Informal document No. **GRSG-90-21** (90th GRSG, 24-28 April 2006 agenda item 2.8.)

Japanese comments on ECE/TRANS/WP.29/GRSG/2006/20

(Regulation No. 58)

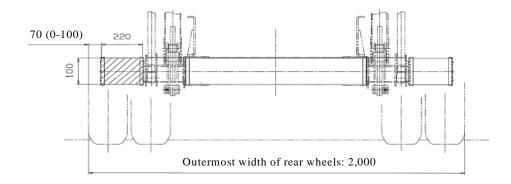
"3.2.1. the lateral distance between the fitting elements of the underrun device and the elements of the platform lift, which make the interruption necessary, may amount to no more than 2.5 cm."

The lateral distance of no more than 2.5 cm is an extremely strict requirement to Japan, because we are currently producing platform lifts with the lateral distance of no more than 10.0 cm to allow for greater freedom of the lift movement. Japan requests provision of justification, such as research paper, for requiring 2.5 cm.
